**PROCEDURE FOR CAPACITIVE SENSOR EXCHANGE**  
- ONLY FOR DRYERS EQUIPPED WITH CAPACITIVE SENSOR (3D SCAN TECHNOLOGY) -

**DESCRIPTION:**

If the capacitive sensor needs to be replaced, this service bulletin describes the correct procedure.

### FERRITE TO BE USED FROM OLD HARNESS

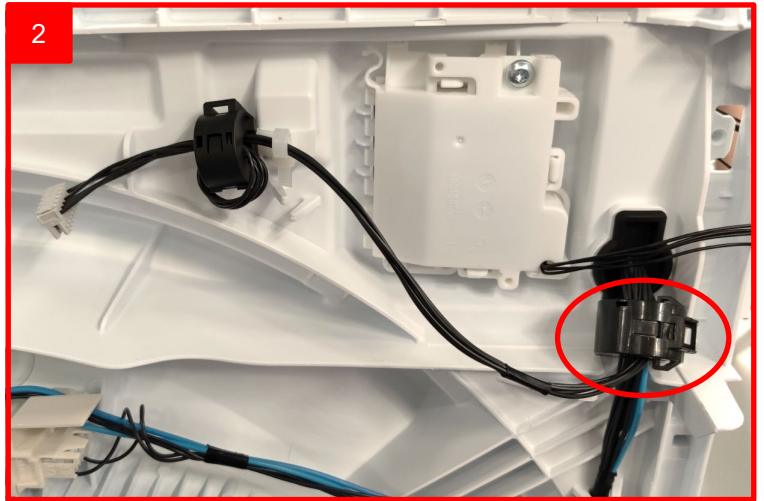
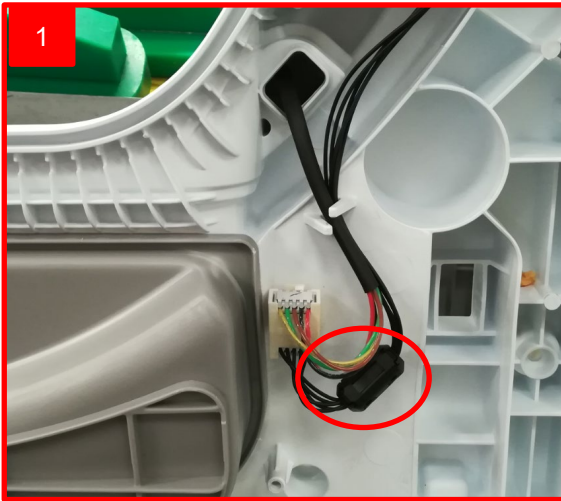
When replacing the wiring harness move the ferrites from the old/replaced wiring harness and locate them in the same places on the new wiring harness

Note please that each ferrite is different, it need be placed in the original place.

**1** Ferrite location at the Capacitive sensor - applicable for all the models (with and without WiFi)

**2** Ferrite location at the WiFi module clamping the wires - applicable only for WiFi models

### AFTER REPLACEMENT OF COMPONENTS FROM HIGHER ELC

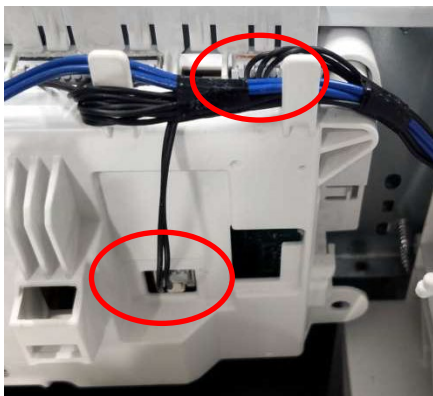
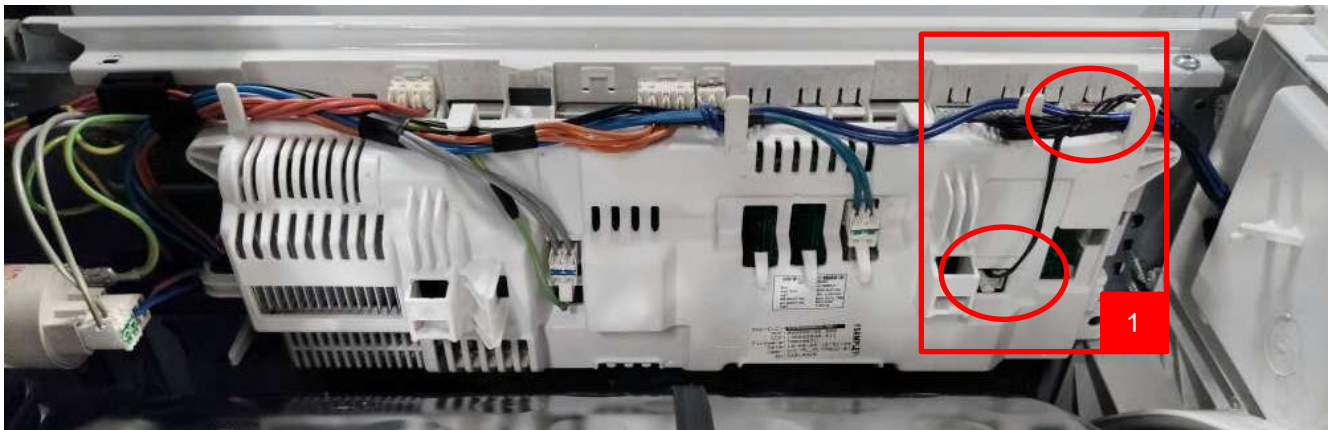
Pictures showing the final connection.

**1** Double wire connection for the new humidity sensor
